STATE OF IDAHO
DEPARTMENT OF WATER RESOURCES
IN-OFFICE REVIEW/BENEFICIAL USE FIELD REPORT

Permit No: 55-13873

Known as Project # 09883 Head of East Fork Spring.

TO: FILE 55-13873
FROM: DANIELLE FAVREAU
SUBJECT: IN HOUSE REVIEW
DATE: OCTOBER 21, 2013

Head of East Creek Spring Development (09883)
Water Right # 55-13873
T. 5s., R. 4w., Sec. 25

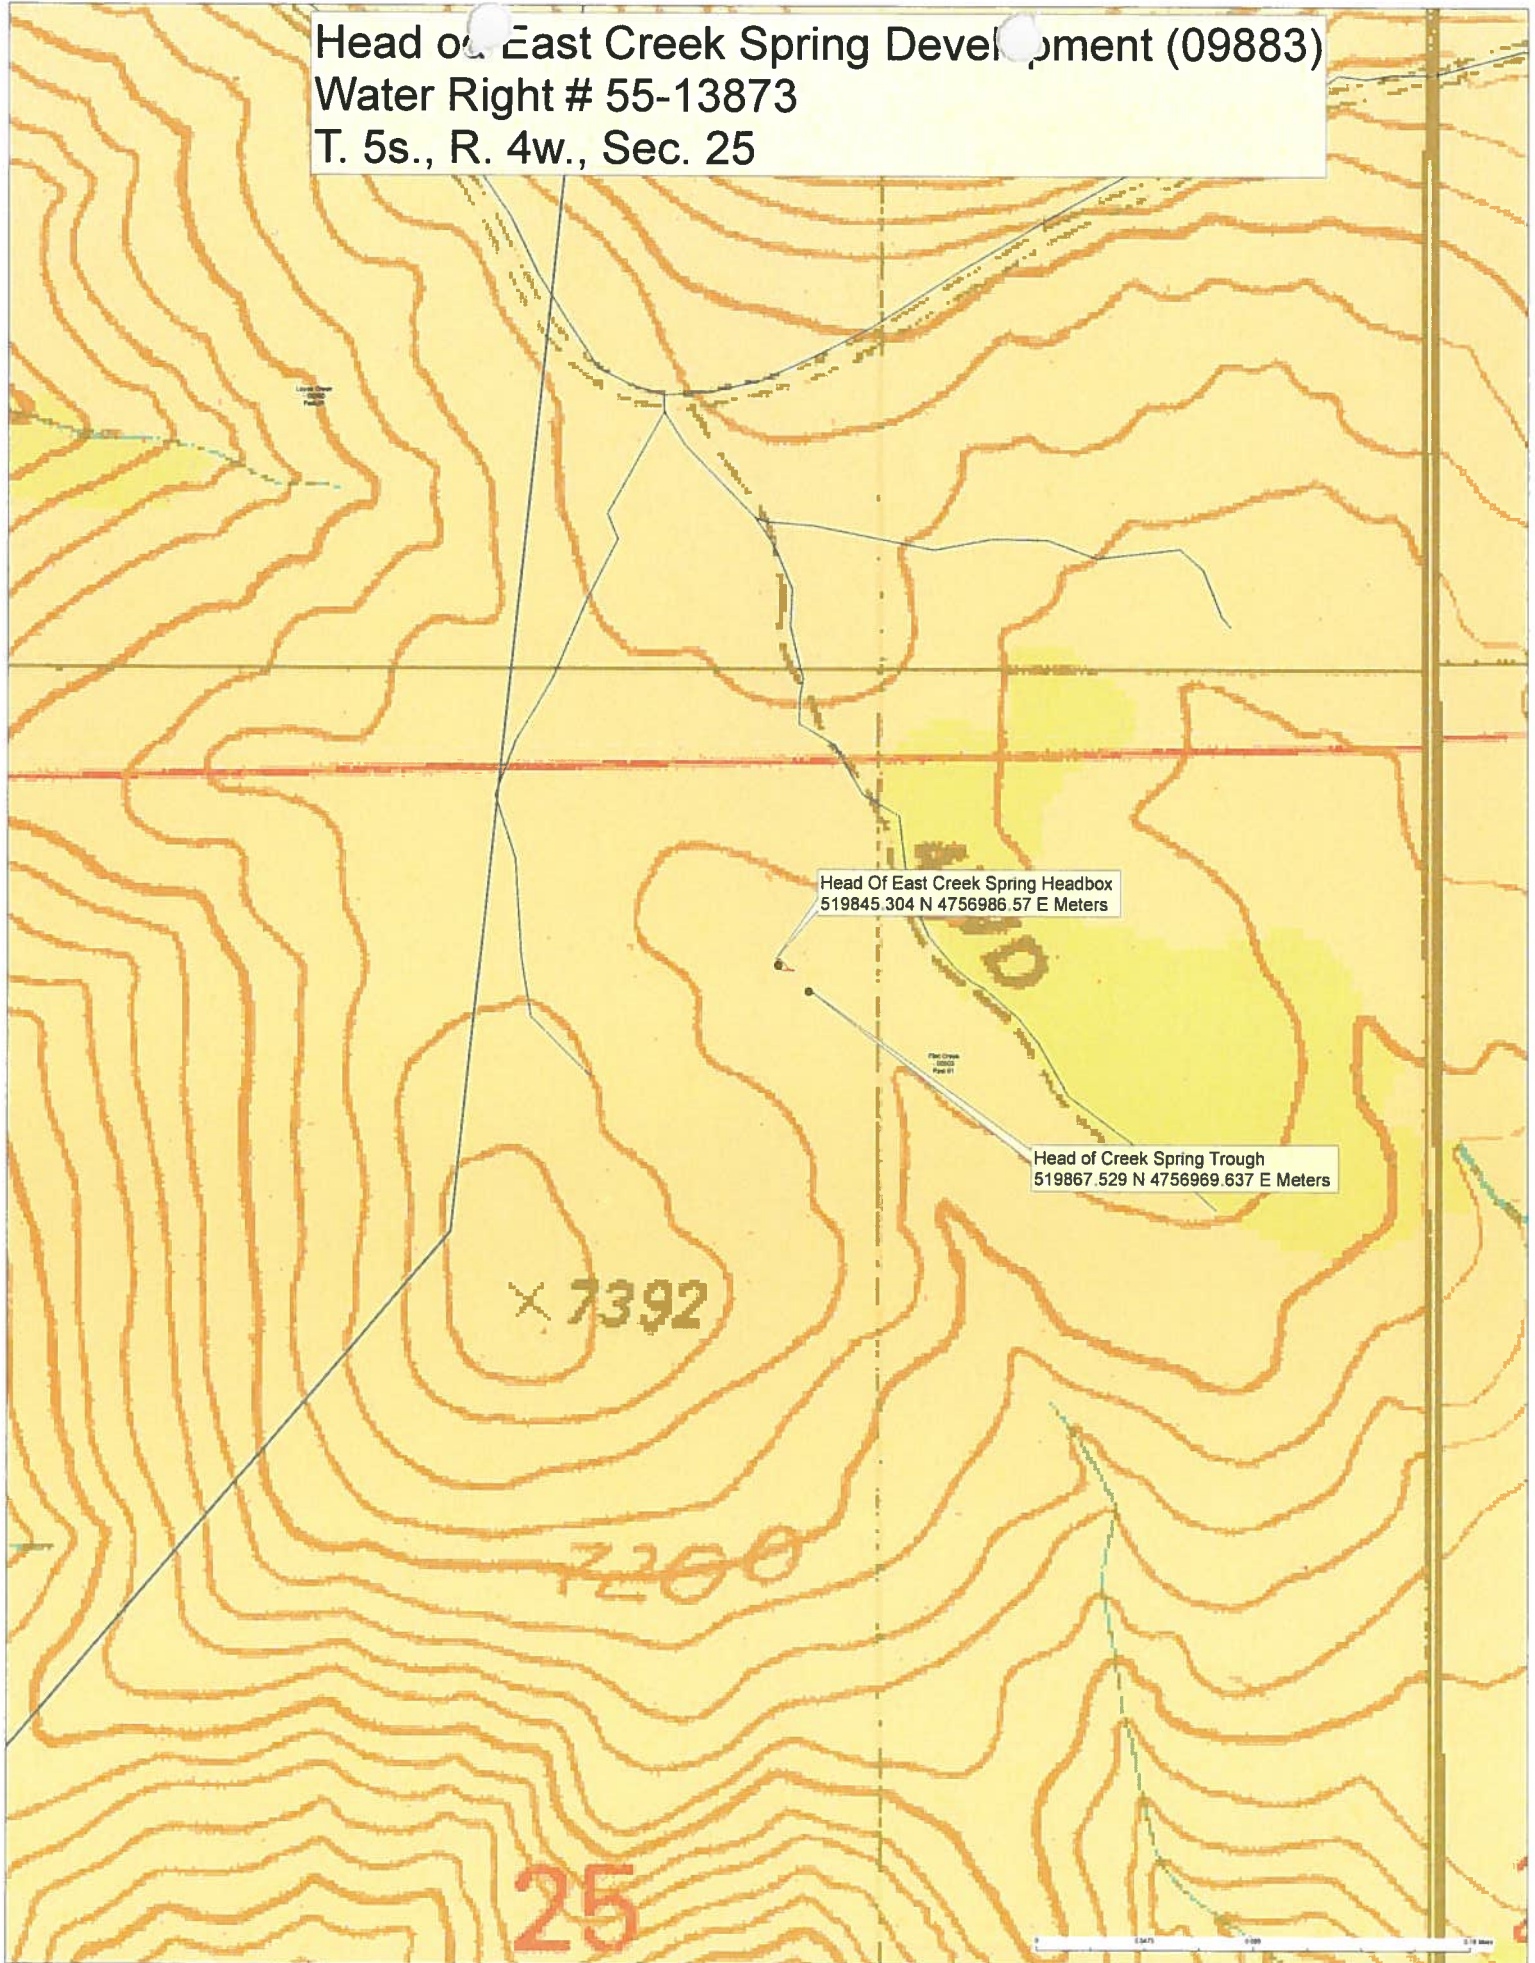
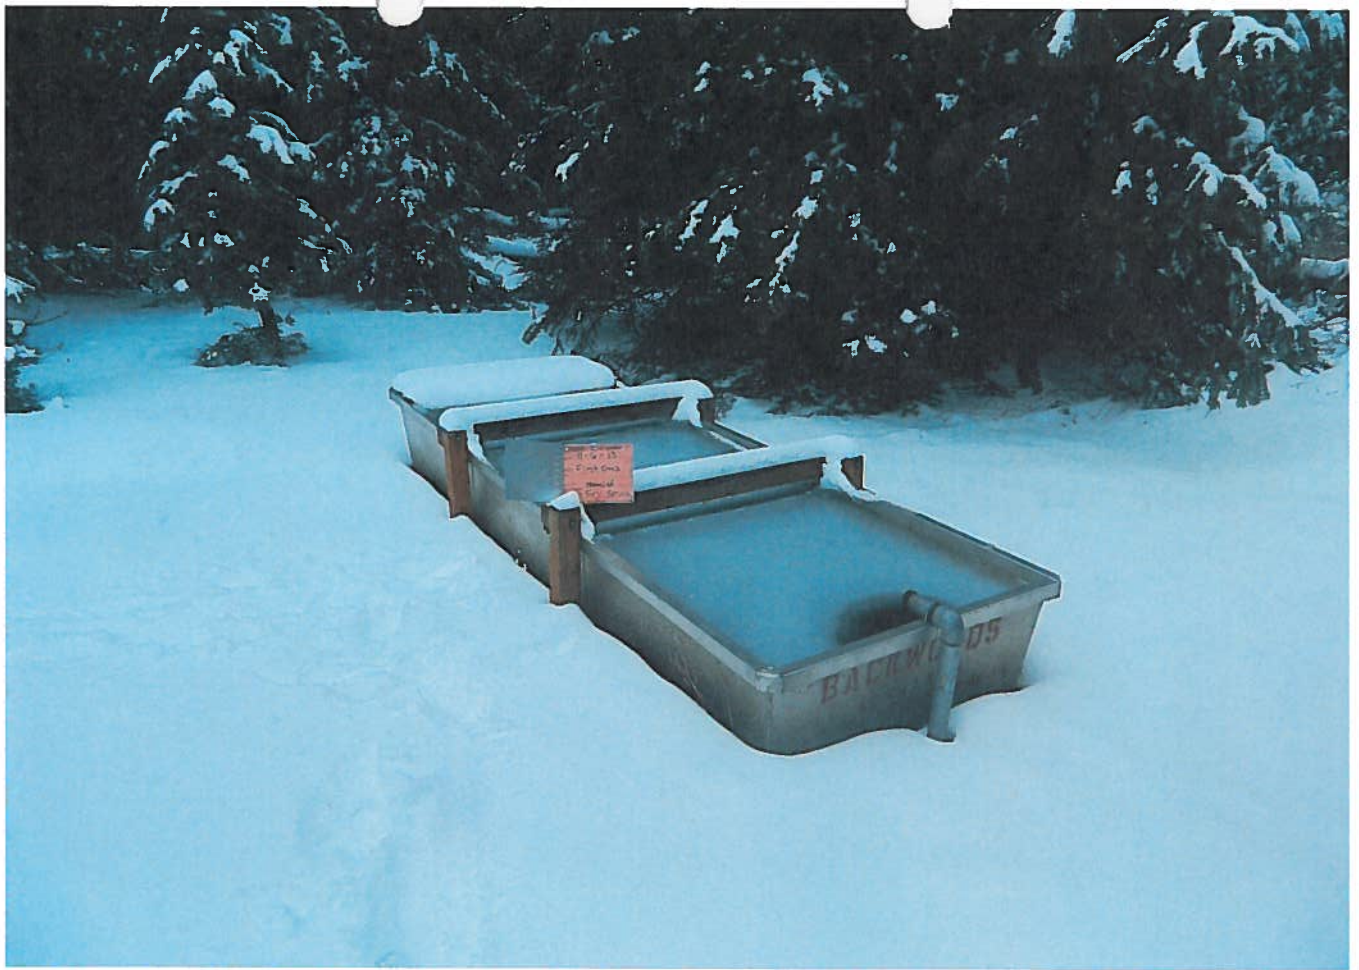
Method of Determination: Trough visible on GIS Imagery – not a pond.

There is no pond associated with this right.

Application was for stockwater and wildlife. Permit changed to stockwater storage/wildlife storage. Diversion is to a trough.

Application was for stockwater and wildlife. Permit changed to stockwater storage/wildlife storage. Diversion is to a trough. Permit had no afa, just a rate. No amendment needed. Storage/wildlife correct use as stated on the application.

Overlap review

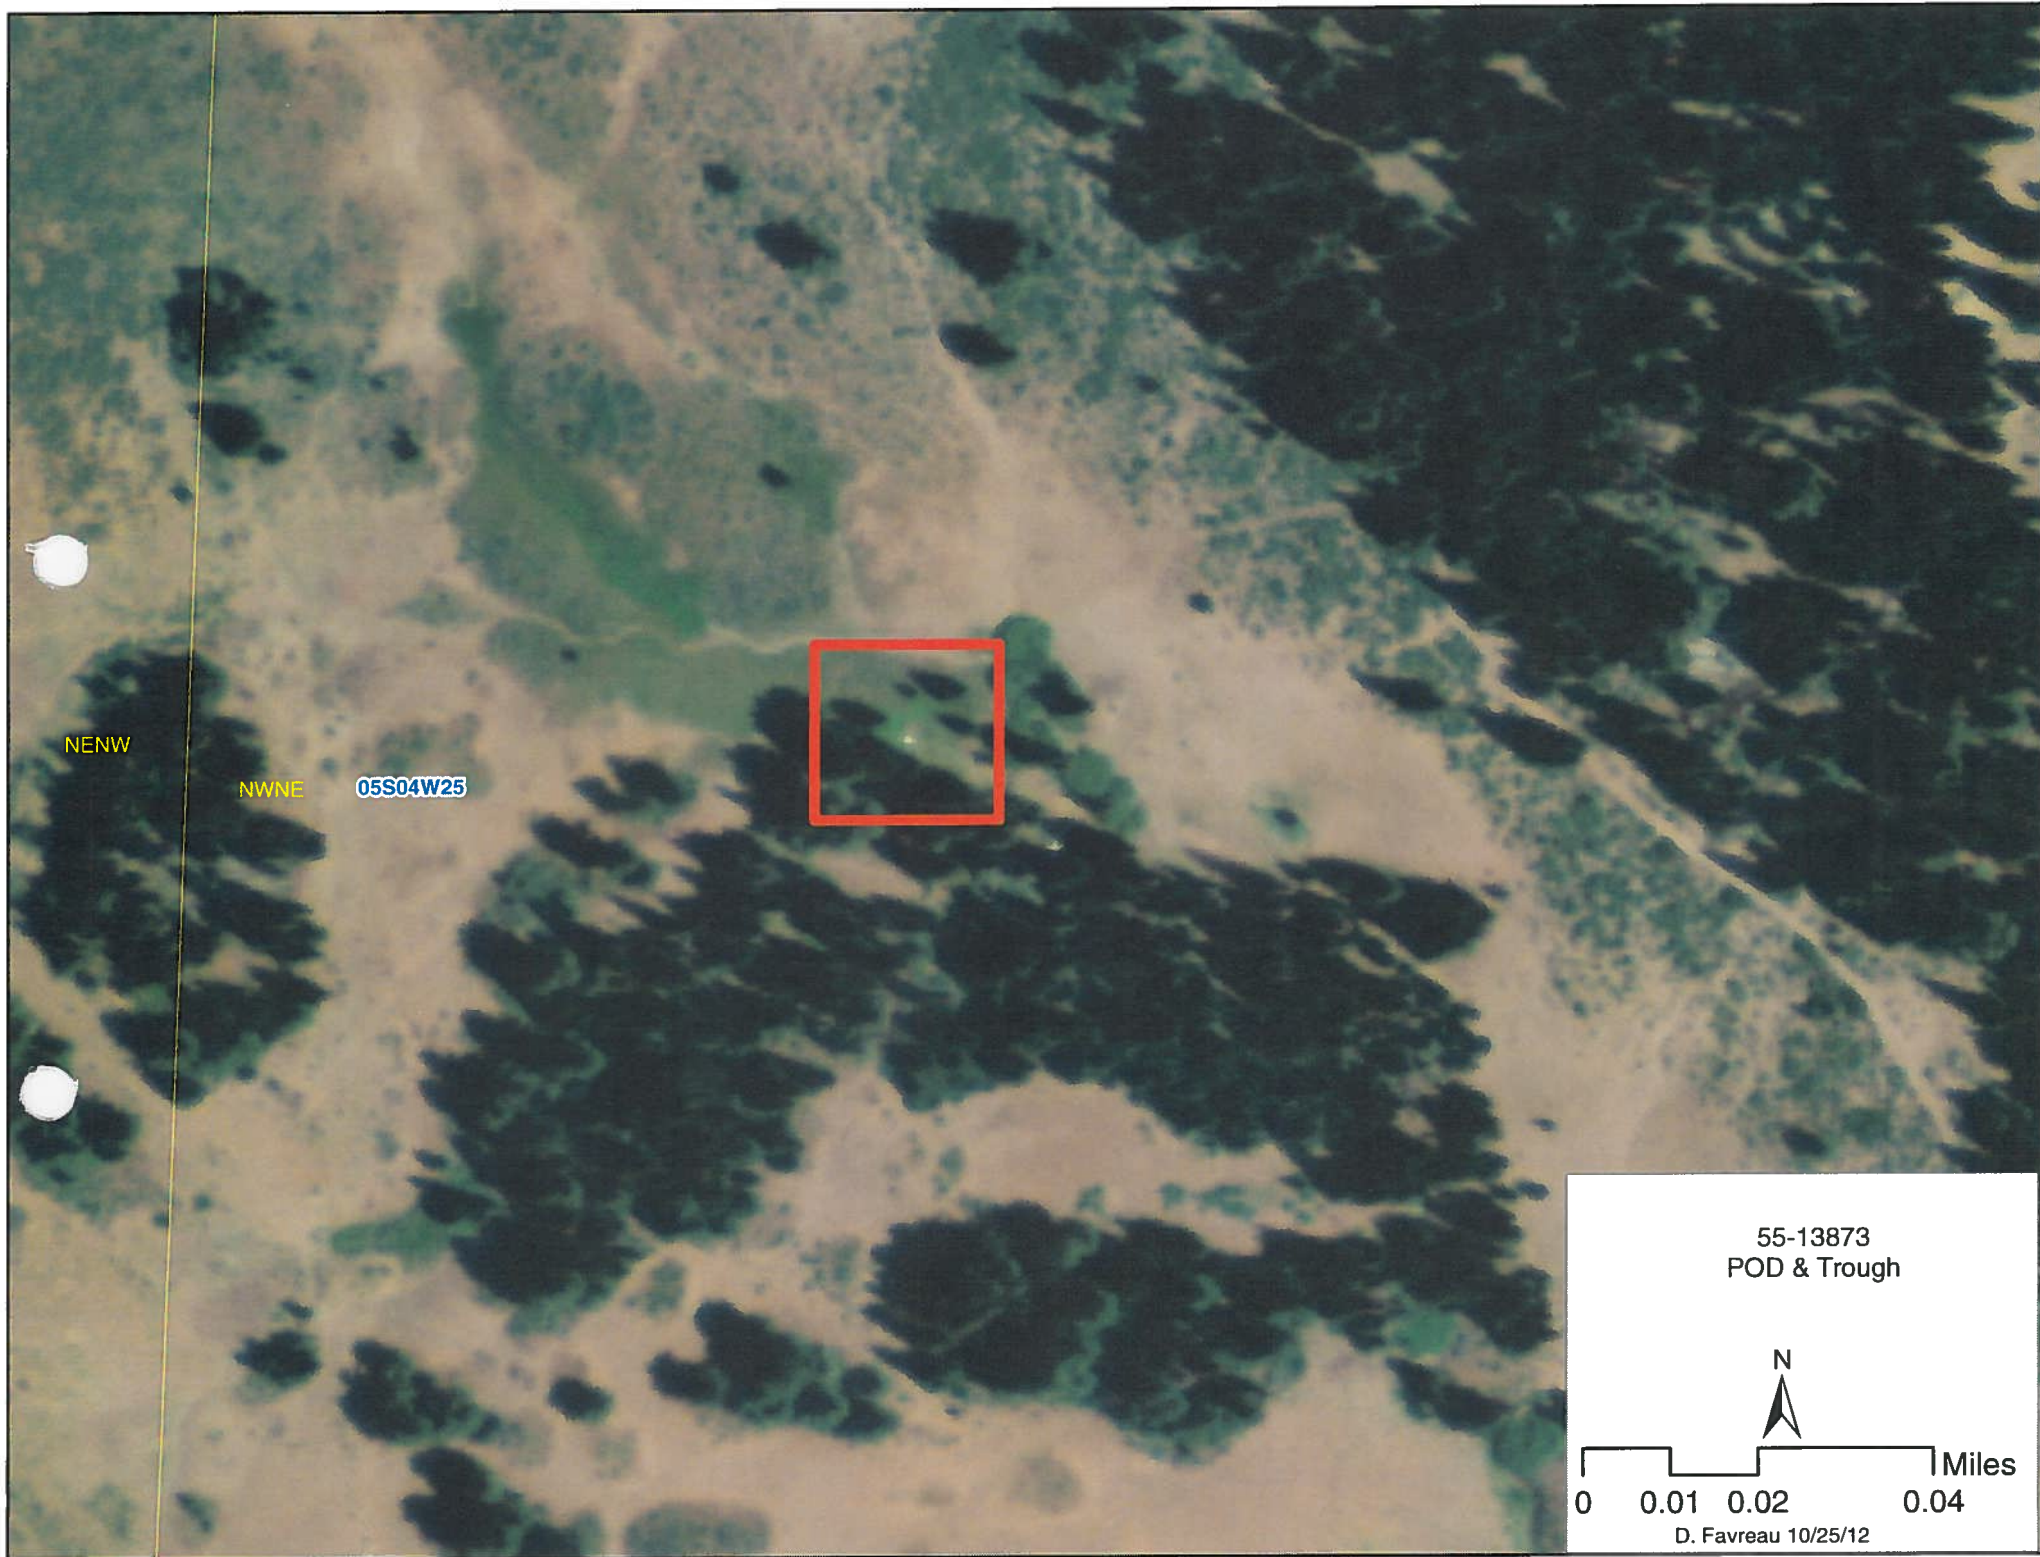
POU – No Overlap
POD – No Overlap

Need GPS of POD and POUs.
Permit is for storage. Cannot find Pond.
